Request for Quotation

RFQ NUMBER
DEP14147

LINE	QUANTITY	UOP	CAT NO	ITEM NUMBER	UNIT PRICE	AMOUNT
	***** ADDENDUM NO. 1 *****					
	ADDENUM ISSUED FOR THE VMS, LTD. PROJECT TO DISTRIBUTE THE PRE-BID SIGN-IN SHEET, THE Q&A, REVISED BID SCHEDULE, AND THE SKIMMER BOARD DETAIL DRAWING AS A RESULT OF THE PRE-BID MEETING OF 06/24/08.					
	BID OPENING DATE AND TIME REMAIN UNCHANGED AS 07/24/08 AT 1:30 PM.					
	***** NO OTHER CHANGES *****					
0001		JB		962-73		
	1					
	RECLAMATION: RESTORATION OF WATER

**Addendum #1 - Questions During Pre-Bid Meeting
For DEP 14149
VMS, Ltd. Permit # S-1045-87**

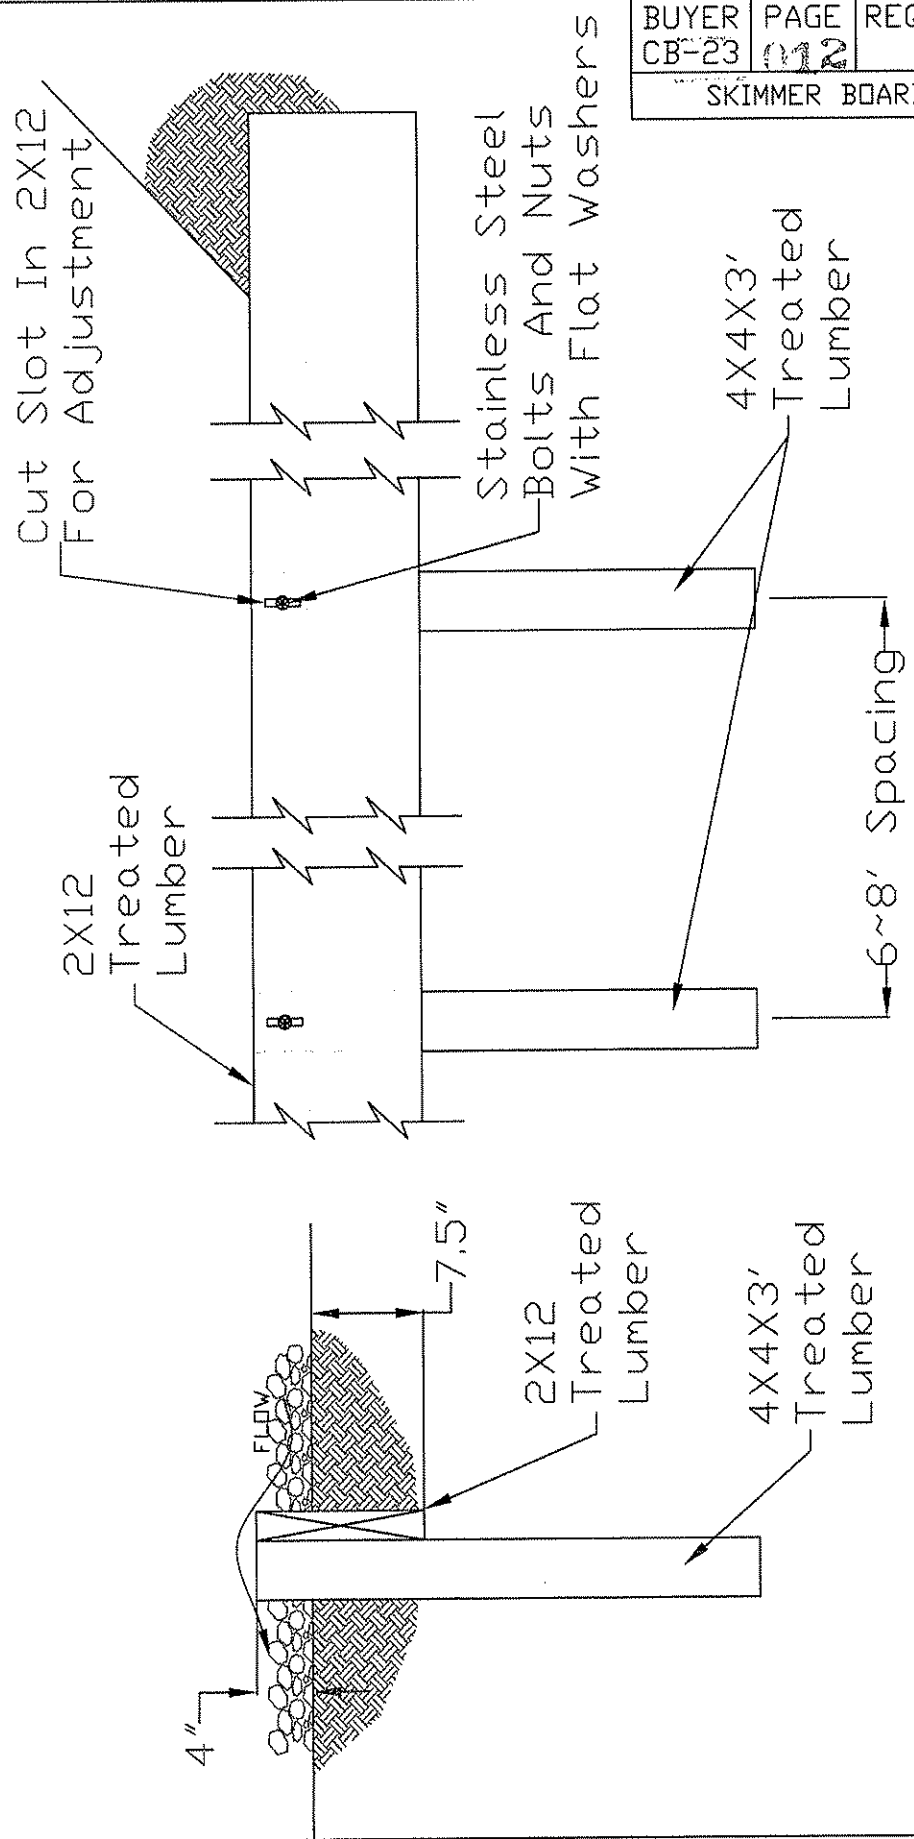
A. Yes, we are lining the inlet and outlet troughs only, not the whole bed or pond.
- 4.) **Q.** Do the skimmer boards have liners attached?
A. No, but the over and under baffles in the manganese removal bed do have liner material attached.

NOTE: The length of board varies with the application. The ends of the skimmer board shall extend two feet into solid material on each side.
